**STAFF RECOMMENDATION**

**328 Harvard Avenue**

**May 20, 2020**

**Application:** Demolition; New Construction—Infill

SITE PLAN  
**A001**

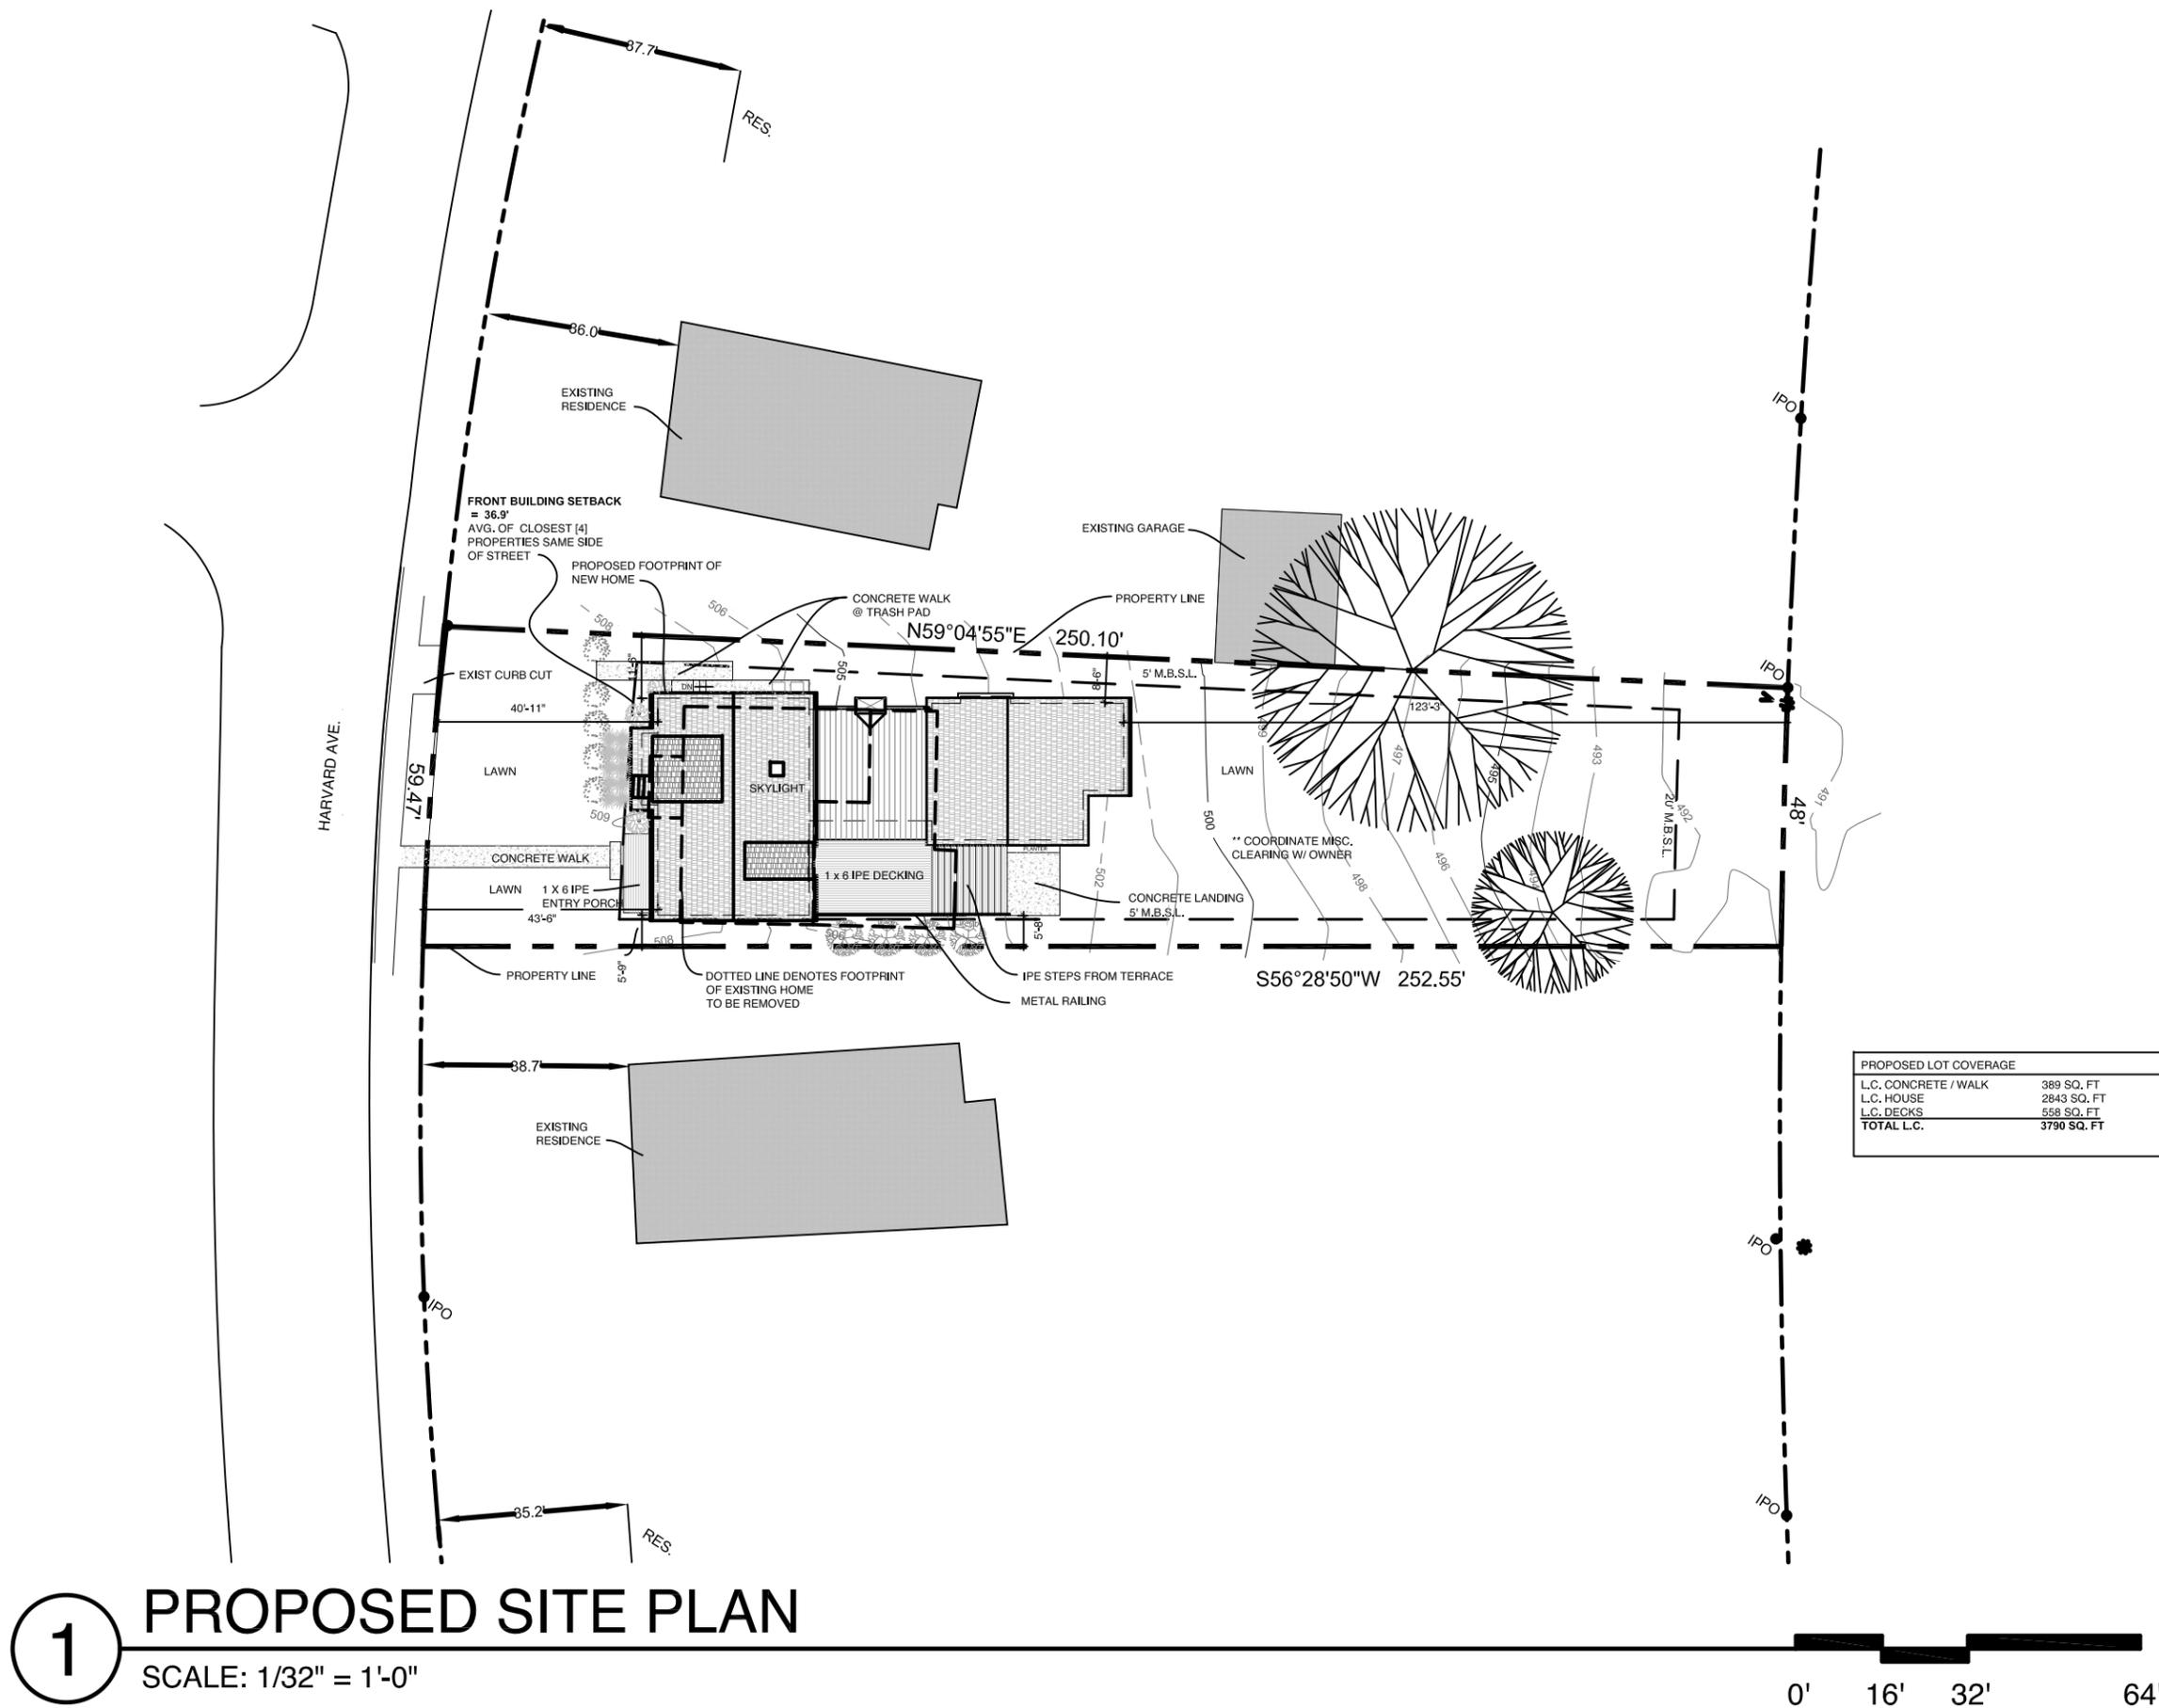
The house will be shifted toward the left side of the lot with a walkway leading from a secondary entrance on the left side and another connecting the front-corner porch to the street in front. Currently, the plan shows the walkway on the left terminating in the front yard, rather than connecting to the sidewalk. Staff recommends that this walkway continue to the sidewalk, and that the existing curb cut is removed.

With a condition that the left side walkway extend to the sidewalk and the existing curb-cut is removed, Staff finds that the house's orientation meets Section II.B.1.f. of the design guidelines.

**MAIN FLOOR PLAN**  
**A101**  
 Do not scale drawings - consult Architect.  
 © Copyright 2020 DAAD, LLC.

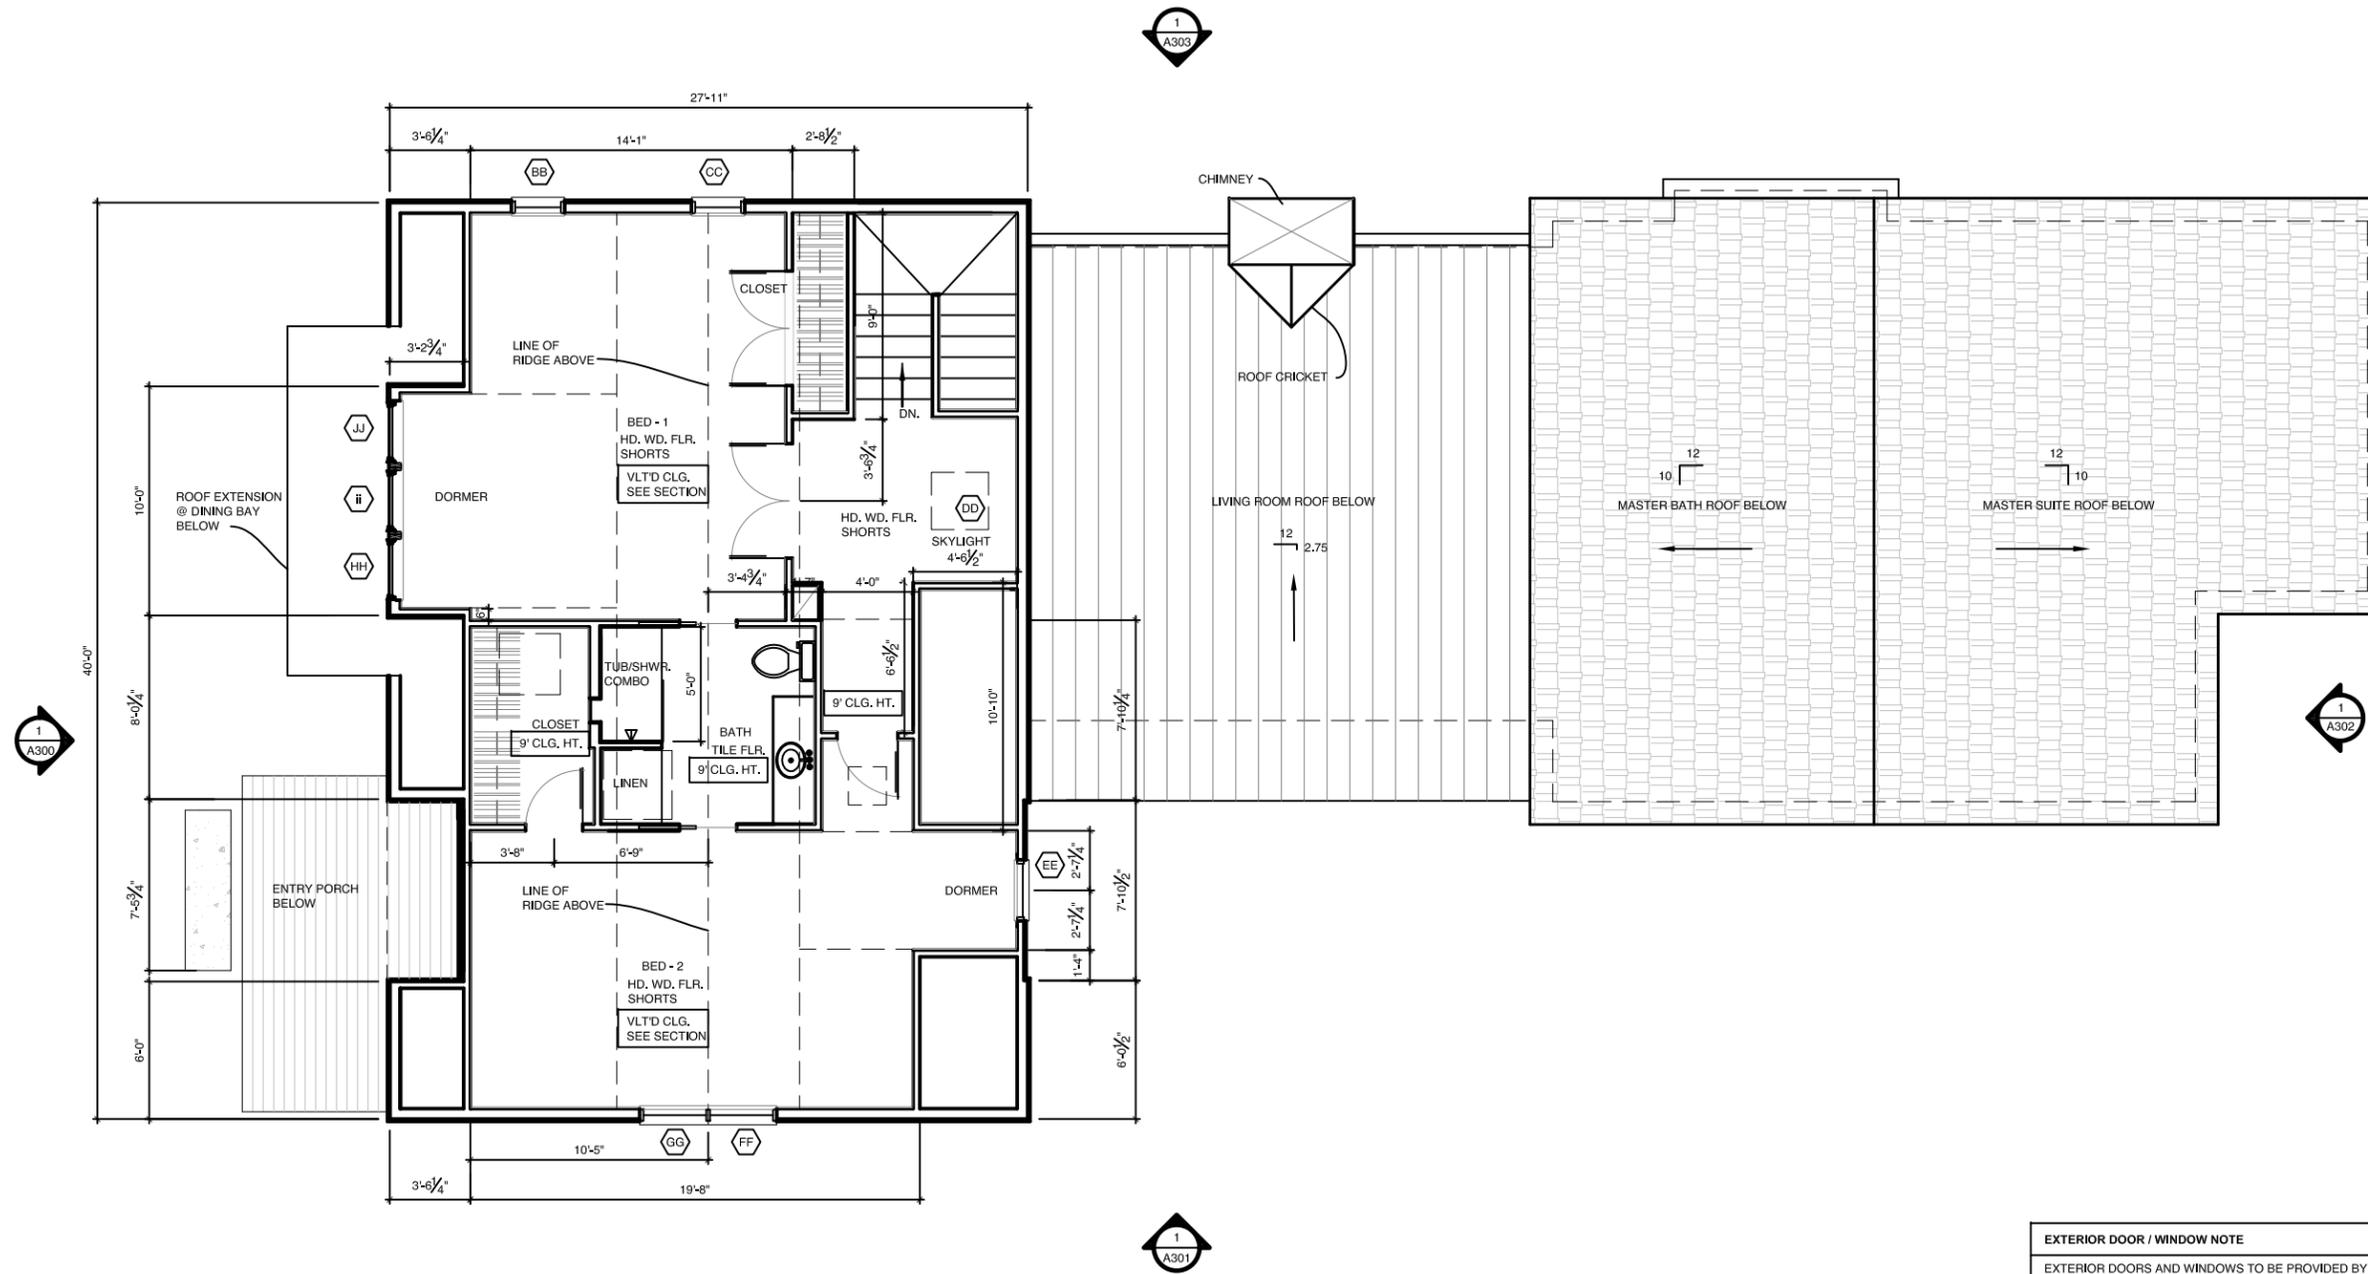
Appurtenances & Utilities: The location of the HVAC is indicated on the proposal as being on the left side, beyond the midpoint of the buildings primary front mass. Staff recommends that the HVAC be located on the rear façade, or on a side façade beyond the midpoint of the house's depth overall.

With the HVAC location as described, staff finds that the project will meet Section II.B.1.i. of the design guidelines.

STREET  
 ELEVATION  
**A300**

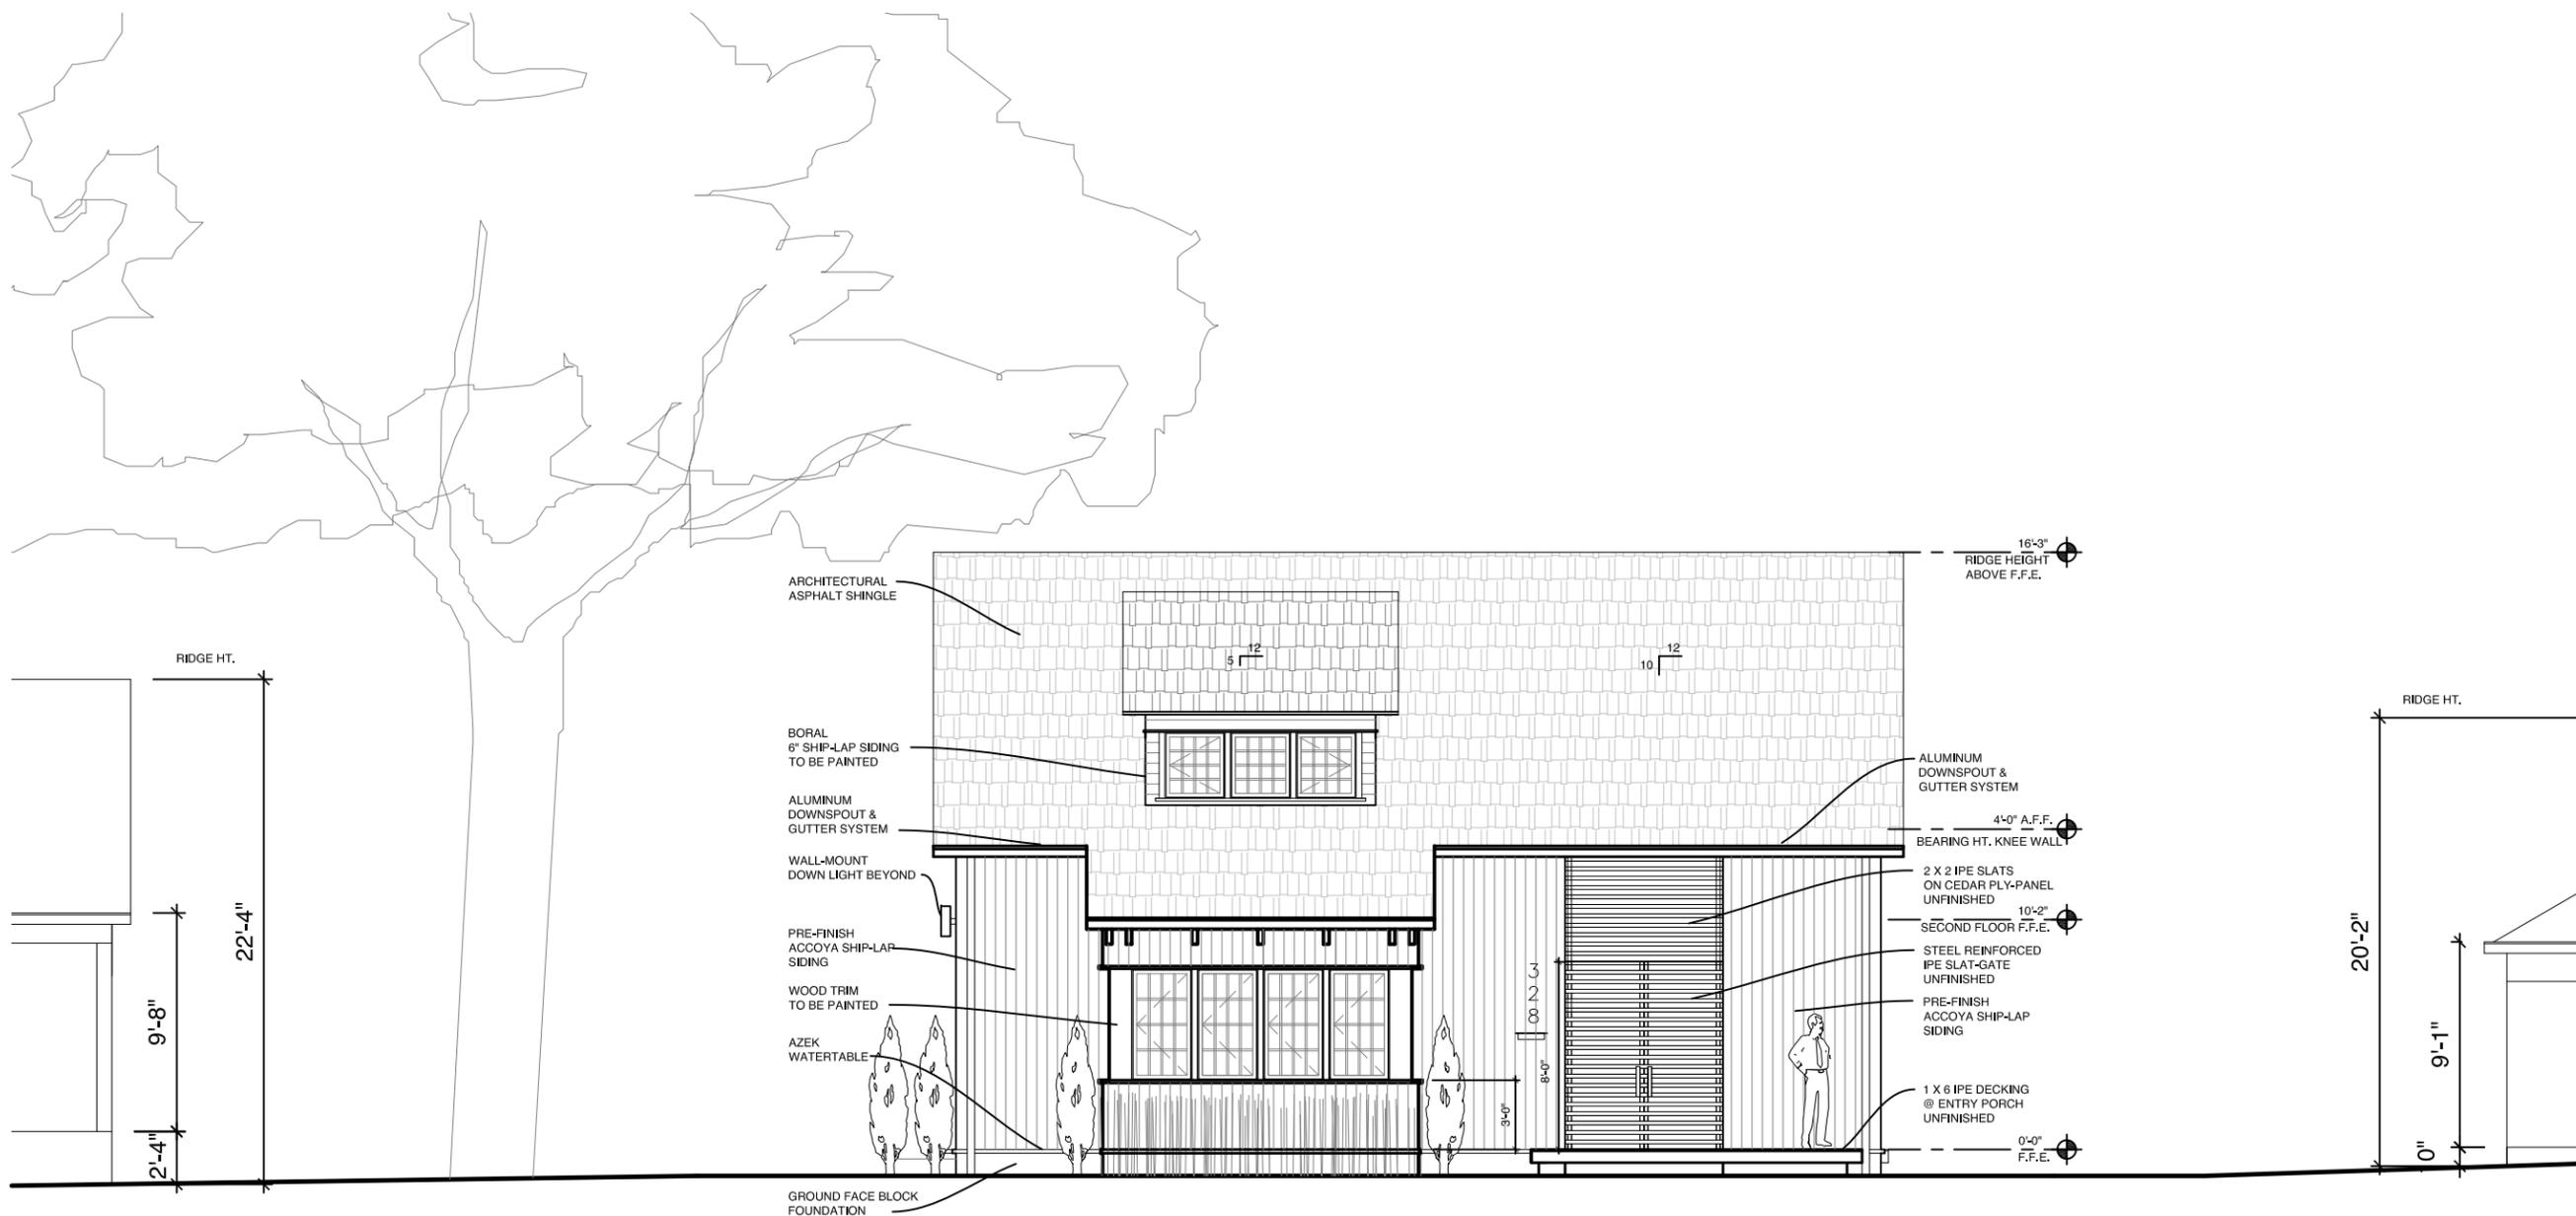
Height & Scale: The proposed infill will be one and one-half-stories with a roof-ridge height of thirty feet (30') above existing grade. The eave height on the house will be fourteen feet (14') above grade, and the foundation will be approximately one foot (1') tall.

The adjacent historic houses to the left and right are twenty-two feet, four inches (22'-4") and twenty feet (20') tall, respectively with eave heights of eleven feet, six inches (11'-6") and nine feet (9'-6") above grade. Other historic houses on the block range between twenty feet (20') and twenty-six feet (26') tall, with foundations approximately one foot (1') to two feet (2') tall.

Staff recommends that the ridge and eave heights of the new house be reduced to twenty-six feet (26') and eleven feet, six inches (11'-6"), respectively, so that neither feature is taller than the corresponding component on any historic house on the block.

Roof form: The primary roof of the building will be a side-oriented gable with a pitch of 10/12, which is repeated in the rear-most mass of the building. The front slope of the roof will feature a shed-roofed dormer with a 5/12 pitch. The front dormer is not stepped back from the primary wall of the house as is typical of most dormers historically, but it will be located above a front projecting bay which gives it an effect similar to being stepped back which staff finds to be appropriate. There will also be a shed dormer on the rear of the primary roof that is not stepped back, however this dormer is sufficiently stepped in from the sides as to not be visible from the right-of-way. These roof forms are compatible with the roofs of nearby historic houses. Staff finds that the project meets section II.B.1.e. of the design guidelines.

With a condition that the ridge and eave heights of the new house be reduced to twenty-six feet (26') from grade and eleven feet, six inches (11'-6") from grade, respectively, so that neither feature is taller than the corresponding component on any historic house on the block., Staff finds that the height and scale of the proposed infill will meet Sections II.B.1.a. and II.B.1.b. of the design guidelines.
